**Lee County, Florida
DEPARTMENT OF COMMUNITY DEVELOPMENT
ZONING SECTION
STAFF REPORT**

Case Number: DCI2022-00027

Case Name: MIVO North Fort Myers

Case Type: Minor Planned Development Rezoning

SHEET NUMBER
MCP-2

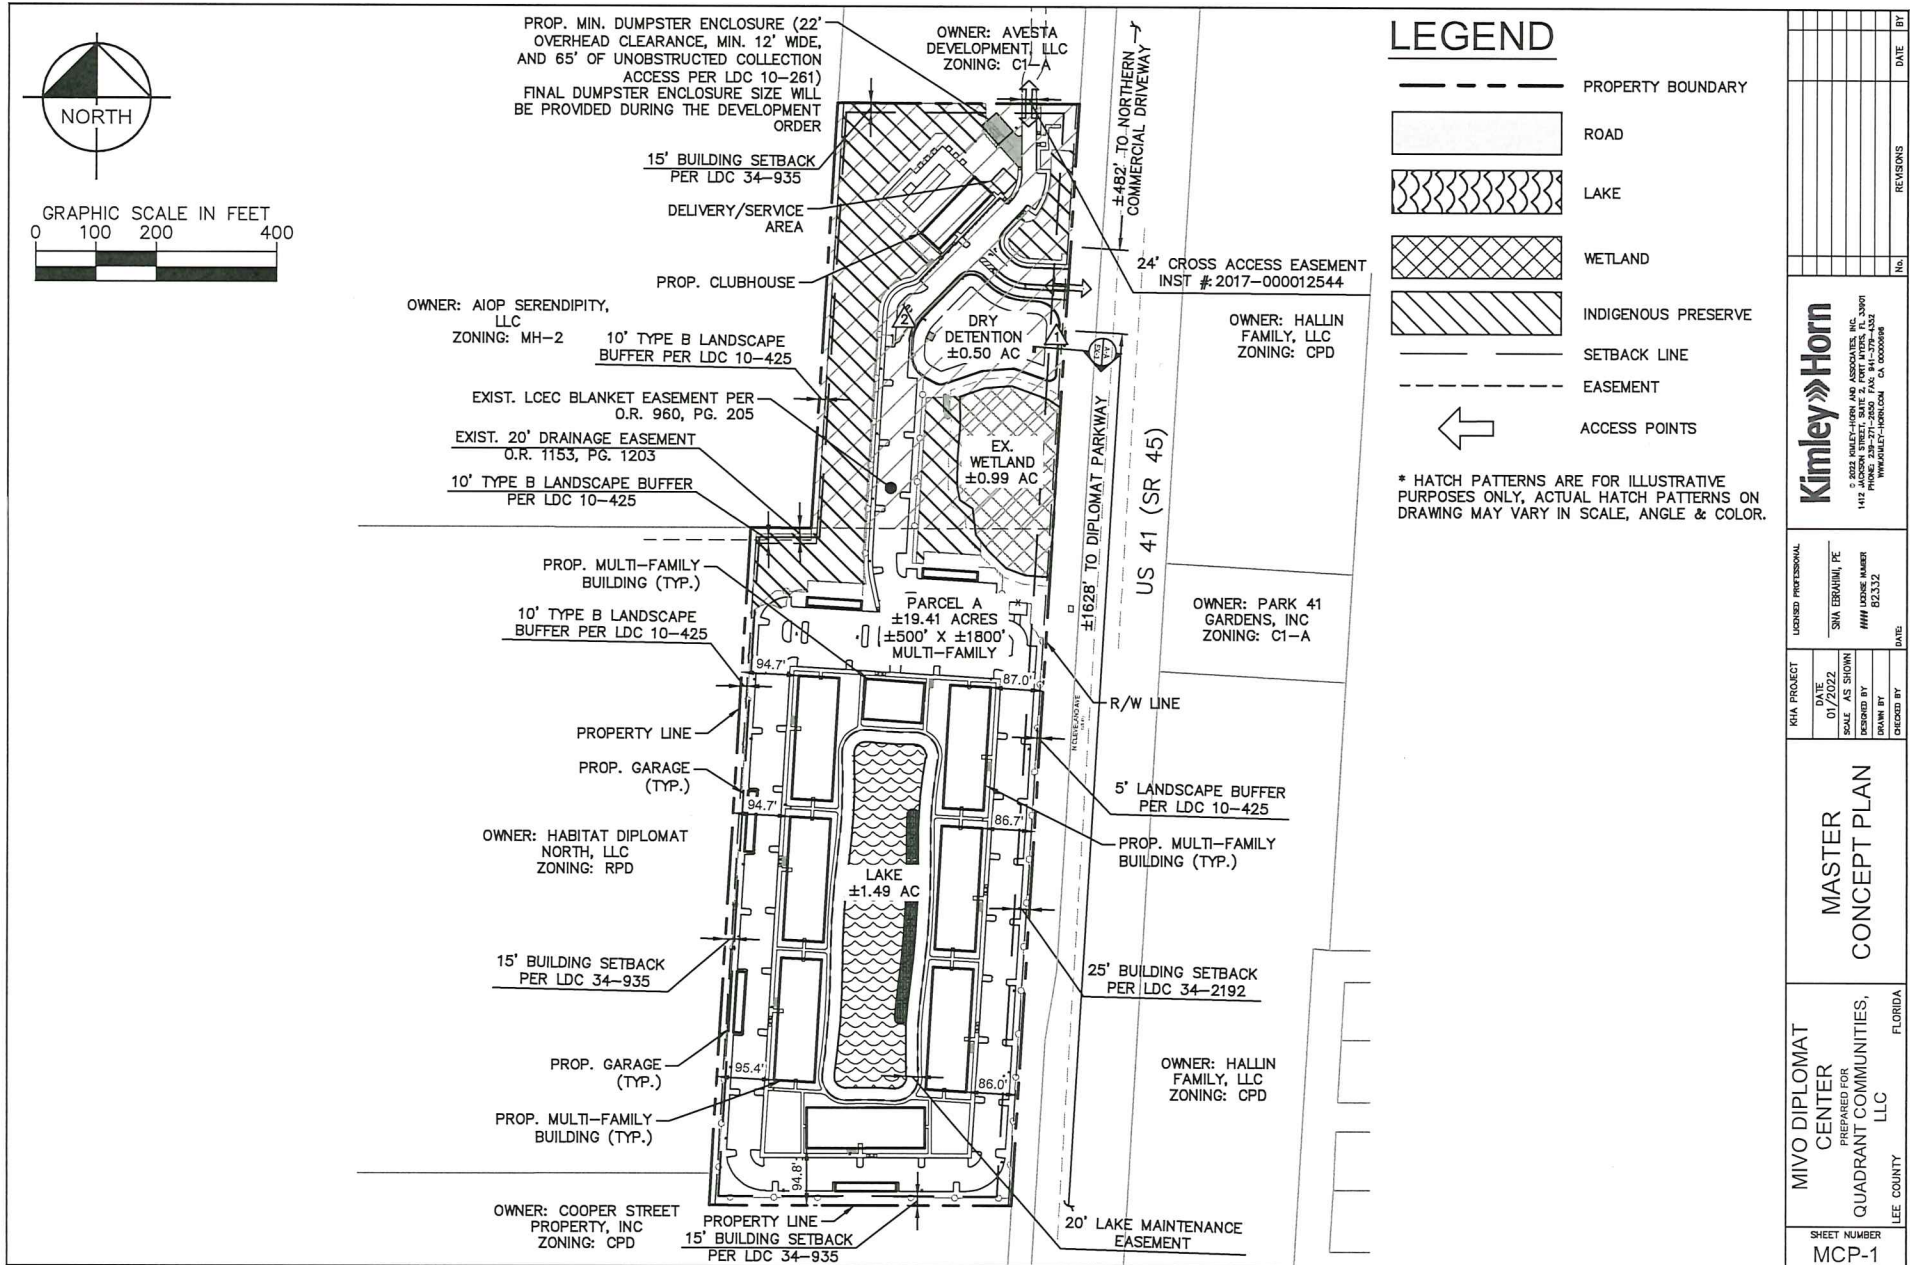
The referenced section applies to excavations. LDC 10-329(a) requires all excavations except moving materials for purposes of surface water drainage (swales, ditches, or dry retention), or landscaping, provided that the excavated materials are not removed from the premises and no blasting is proposed to meet excavation setbacks. The applicant's initial Master Concept Plan included a wet detention lake adjacent to US41. In a subsequent submittal, the wet detention lake was converted to dry detention. The dry detention area is not required to meet the excavation setbacks in LDC 10-329(a), therefore, the deviation request is not applicable. Furthermore, the applicant stated in their response letter dated July 6, 2022 that the requested deviation has been removed and lakes would comply with setback requirements. Staff recommends the Master Concept Plan be revised to remove the reference to deviation (1).

At time of development order the plans must include signage and pavement striping that reserves the area required to execute a three point turning movement on the ingress side of the proposed entrance gate.

In the justification submitted by the applicant the improvements to provide the three point turn will be provided in area reserved for the mail kiosk and trash compactor on the ingress side of the proposed gate. Additionally, the applicant has stated that on-site management staff will be available to assist in allowing vehicles through the gate to turn around if necessary. Staff recommends the following condition to ensure sufficient room is reserved on the ingress side of the gate:

6. At time of development order the applicant must submit an autoturn analysis that demonstrates sufficient area is provided to allow a three point turning movement, on the ingress side of the proposed entry gate, for a single unit truck (SU) as specified in the ASASHTO Green Book, current edition.
7. Turnaround Signage and Striping.
At time of development order, the plans must include signage and pavement striping that reserves the area required to execute a three point turning movement on the ingress side of the proposed entrance gate.
